RE: 1026 to 1052 Hunt Club Road
Environmental Impact Statement and Tree Conservation Report (Revised) - Addendum #1

Technical comments from the City and MVCA were received on October 20th, 2017 and October 3rd, 2017 (respectively) (City File: D07-12-17-0068). The purpose of the current letter (EIS Addendum #1) is to provide additional detail in response to the City and RVCA's technical comments. This EIS Addendum #1 should be read in conjunction with the report entitled *Environmental Impact Statement and Tree Conservation Report (Revised) 1026 to 1054 Hunt Club Road, Ottawa, ON* (MES 2017). For brevity, natural heritage features that were previously discussed and adequately addressed in the EIS and TCR are not revisited in this EIS Addendum #1. Refer to the EIS and TCR for additional detail on surveying methodology, existing conditions, impact assessment, and mitigation for any natural heritage features not discussed in this EIS Addendum #1. Figures included in this report replace any previously submitted figures.

**Site Plan at
Ground Floor Level**

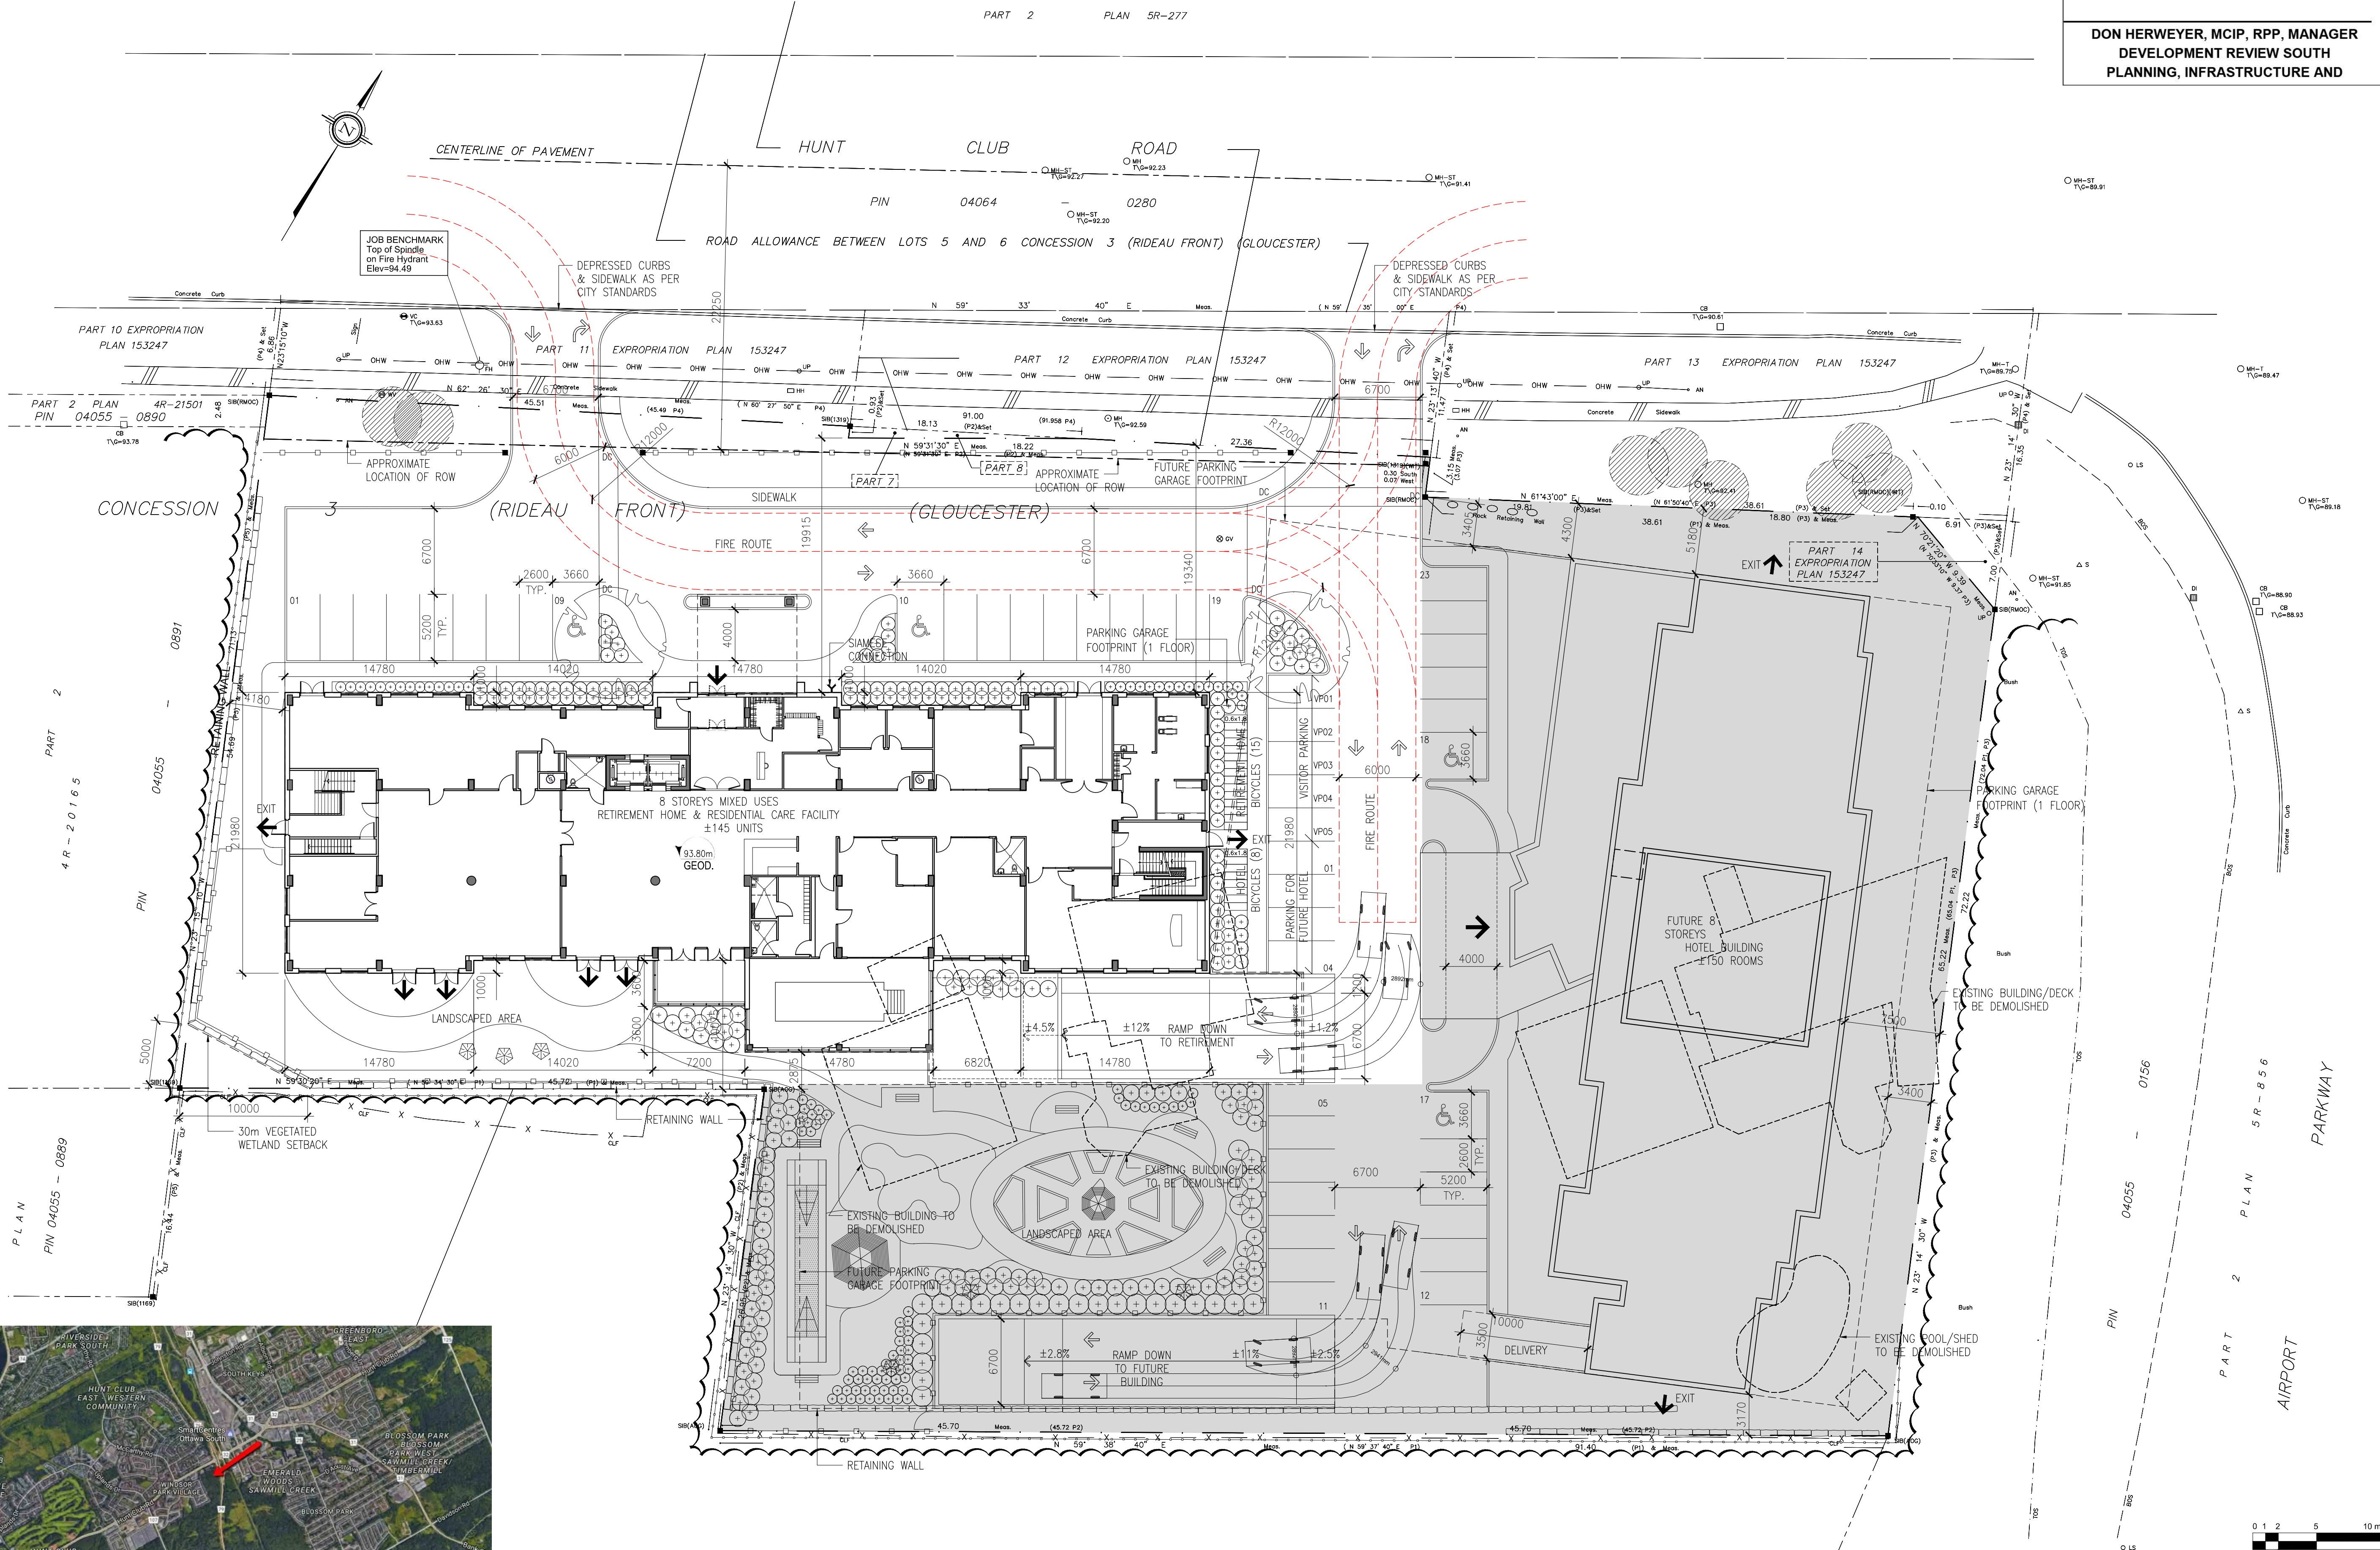
- **Leitrim Road Provincially Significant Wetland (LRPSW) Setback:** The RVCA stated that the reduced setback of 27 m in the southwest corner of the Site was not sufficient. It was requested that the wetland setback be re-evaluated;

In response to RVCA comments, the Site Plan (above) has been adjusted so that the retaining wall, fence, and all other infrastructure/development activities will be oriented to provide a minimum 30 m setback from the wetland edge throughout the Site. As shown in Figure 3 (below), the minimum 30 m setback from the wetland edge overlaps the southwest corner of 1026 Hunt Club Road. The area where the minimum 30 m setback overlaps the Site is approximately triangular in shape and measures approximately 5 m x 10 m (measured along the property line). The Site Plan has been adjusted to move the retaining wall, fence, and all other development activities outside of the 5 m x 10 m triangle in the southwest corner of 1026 Hunt Club Road, thereby providing a minimum 30 m setback from the wetland edge. The 5 m x 10 m triangle is currently developed and includes an area of compacted gravel. During development, the compacted gravel will be removed and trees will be planted to reforest the 5 m x 10 m triangle. Reforestation of the 5 m x 10 m triangle increases the total extent of tree planting that will be undertaken as part of the development, while also restoring the functionality of the minimum 30 m wetland setback, where it overlaps the Site. The Landscaping Plan has been adjusted to show additional tree planting within the 5 m x 10 m triangle in the southwest corner of 1026 Hunt Club Road.

FIGURE 3: WETLAND SETBACK

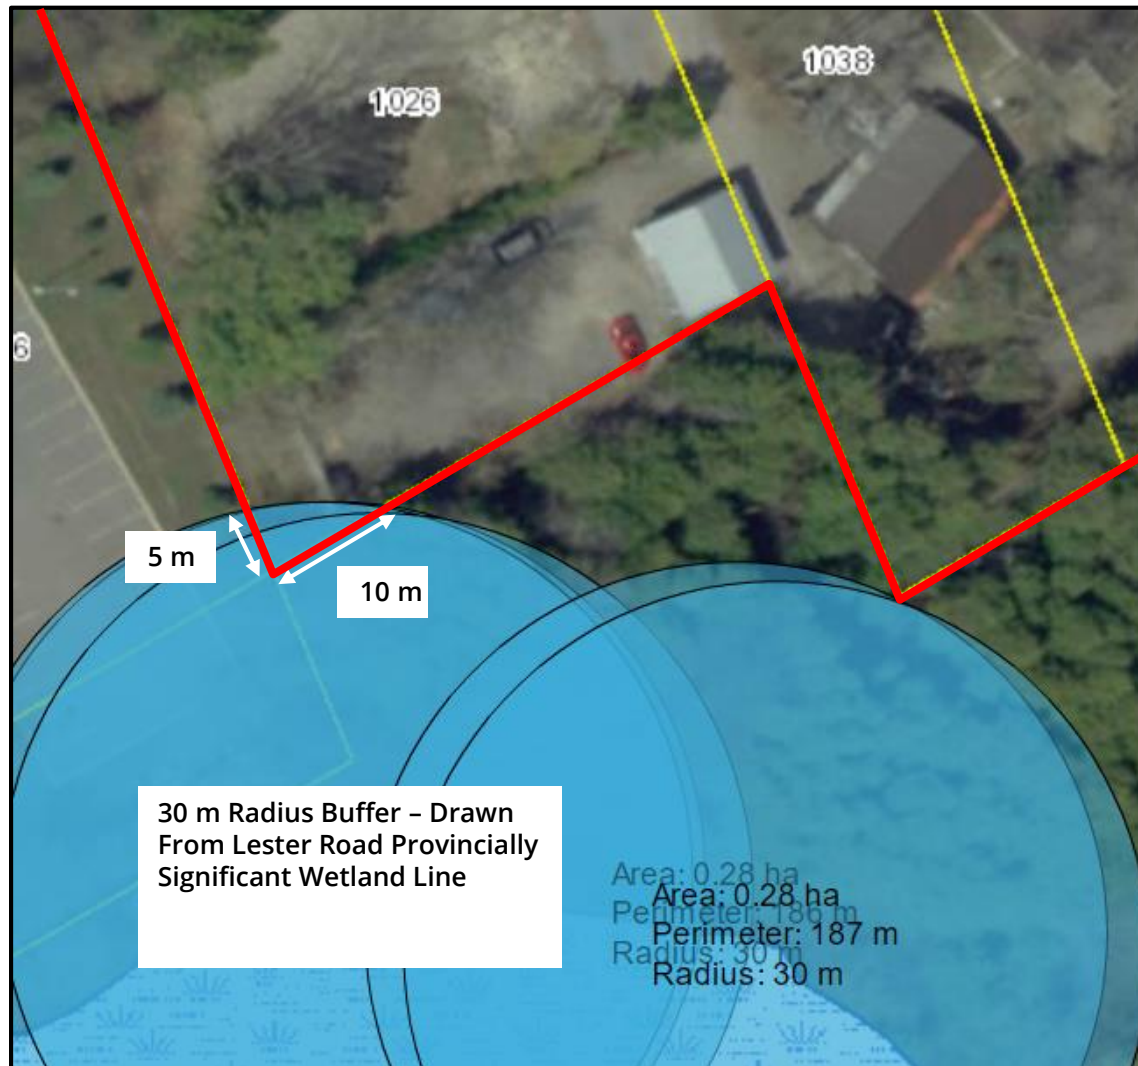
As shown in Figure 1, the distance between the LRPSW and the property line varies between approximately 27 m and 115 m. The distance between the wetland edge and the property line is narrowest (27 m) in the southwest corner of 1026 Hunt Club Road. In the EIS and TCR, it was previously proposed that a retaining wall and fence would be constructed along the property line. This would have placed the retaining wall 27 m from the wetland edge in the southwest corner of 1026 Hunt Club Road, thereby providing 27 m of forest between the wetland edge and the limit of development. It was also proposed that the 27 m setback from the wetland edge would be supplemented with a 10 m wide landscaped area, which would have been included on the development side of the retaining wall, within the southwest corner of 1026 Hunt Club Road. The RVCA stated that this arrangement was not sufficient to provide an adequate wetland setback.

With the adjusted wetland setback implemented, the Site Plan now provides a forested wetland setback that varies between approximately 30 m and 115 m throughout the Site. The 30 m to 115 m wide vegetated wetland setback will help to slow, filter and absorb overland stormwater flow, it will provide habitat for wildlife, and it will also provide a buffer from edge effects, noise, pollution, and other forms of human disturbance. The adjusted wetland setback achieves a minimum of 30 m setback across the Site, and hence is anticipated to be sufficient to protect the features and functions of the LRPSW.
